Access Compliance Report

Public Rights-of-Way

(Curb Ramps)

Intersection ID: 10038838	Main Street: STEELECROFT_PY	Cross Street: N/A	Location: E
ADA ID: 23D9C68E2D7A	Ramp Type: PerpDiag	Initial Pass/Fail: Fail	Overall Compliance: No
Severity Score: 21.25			
Codes/Mitigation Info/Possible Solution		Field Measurements/Component Compliance

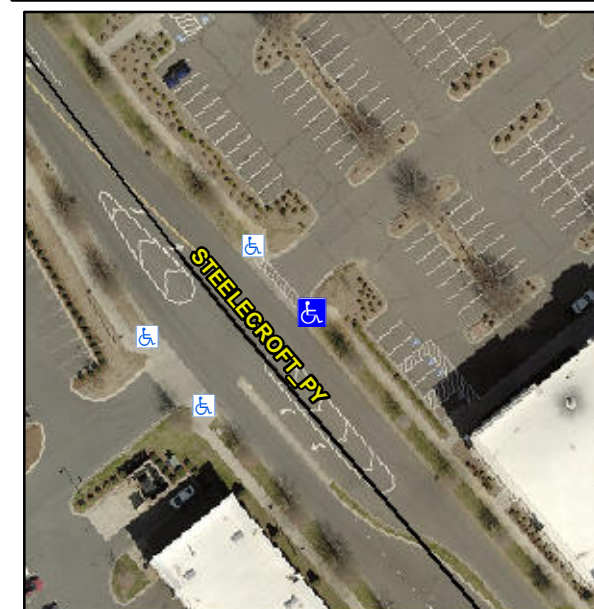
Not Found, R304.5.1, R304.2.2

Compliance	Description	Data	Compliance	Description	Data
N/A	Ramp Length (in)	99.0	No	Ramp Slope (%)	9.1
No	Ramp Width (in)	42.5	Yes	Ramp XSlope (%)	0.7
N/A	Flare Type LT	N/A	N/A	Flare Type RT	N/A
N/A	Flare Slope LT (%)	N/A	N/A	Flare Slope RT (%)	N/A
N/A	Flare Traversable LT?	N/A	N/A	Flare Traversable RT?	N/A
N/A	Landing Length (in)	N/A	N/A	DWS Provided?	N/A
N/A	Landing Width (in)	N/A	N/A	DWS Contrast?	N/A
N/A	Landing Slope (%)	N/A	N/A	DWS Length (in)	N/A
N/A	Landing X Slope (%)	N/A	N/A	DWS Full Width?	N/A
N/A	Landing Curb? (Y/N)	N/A	N/A	DWS Offset (in)	N/A
N/A	Shared Landing?	N/A			
N/A	Gutter Ponding?	N/A	N/A	Gutter Slope (%)	N/A
N/A	Gutter Lip Ht (in)	N/A	N/A	Gutter X Slope (%)	N/A
N/A	Painted X Walk1?	Yes	N/A	Painted X Walk2?	No
	X Walk 1 Direction	To NW		X Walk 2 Direction	To SW
N/A	X Walk 1 Width (in)	52.0	N/A	X Walk 2 Width (in)	N/A
	X Walk 1 Slope (%)	0.7		X Walk 2 Slope (%)	0.8
	X Walk 1 X Slope (%)	2.9		X Walk 2 X Slope (%)	0.5

Remove & Replace Curb Ramp With Two New Directional Ramps or Equivalent.
